Intel[®] Pentium[®] III Xeon[™] Processor Specification Update

Release Date: August 2000

Order Number: 244460-018

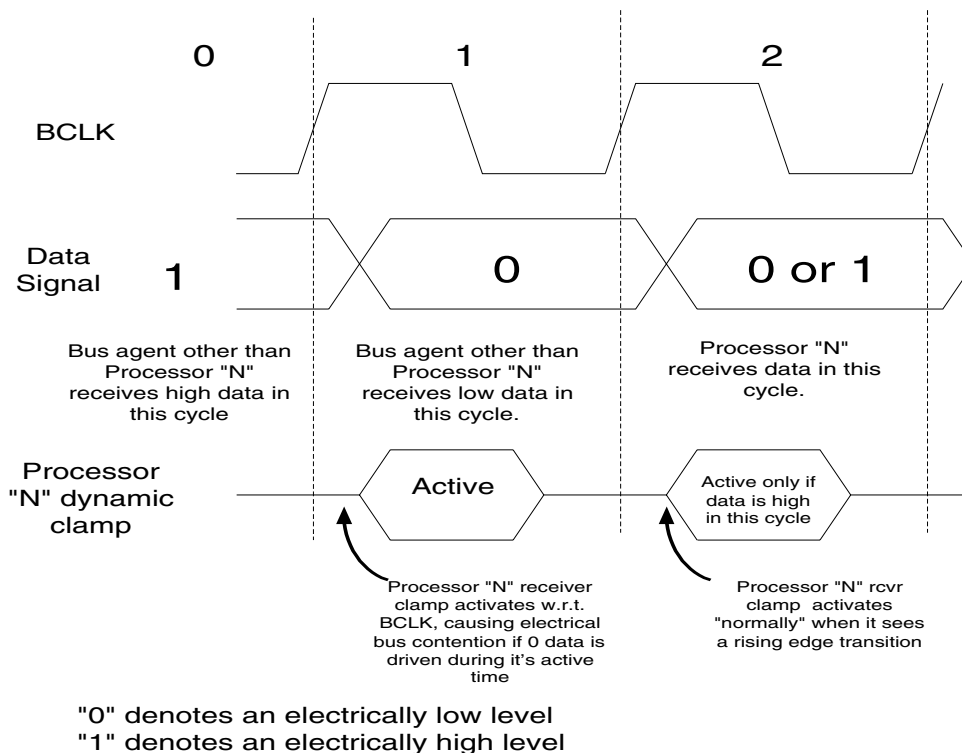
Workaround: The AGTL+ V_{REF} (input voltage reference) level will be raised from 1.0V to 1.1V (assuming a V_{TT} of 1.5V) on the processor cartridge substrate. This allows the dynamic clamp to activate at a trigger level approximately 100 mV higher than with the previous 1.0V V_{REF} setting. Due to the dependence upon system bus design, bus layout may be evaluated to determine the need for improvements in falling edge ringback levels. This may involve one or several of the following baseboard modifications:

1. Change termination resistor value to reduce multi-bit noise and/or improve V_{IL} noise margin.
2. Reduce multi-bit noise by improving ground return paths (additional high-frequency decoupling, improved AC plane referencing, etc.).
3. Raising or lowering the V_{TT} level (within the AC & DC tolerances specified in the processor EMTS) to improve V_{IL} noise margin and/or reduce the multi-bit noise due to dl/dt transients.

Stress tests using various data patterns and transactions should be run to identify the worst-case multi-bit noise conditions for this erratum.
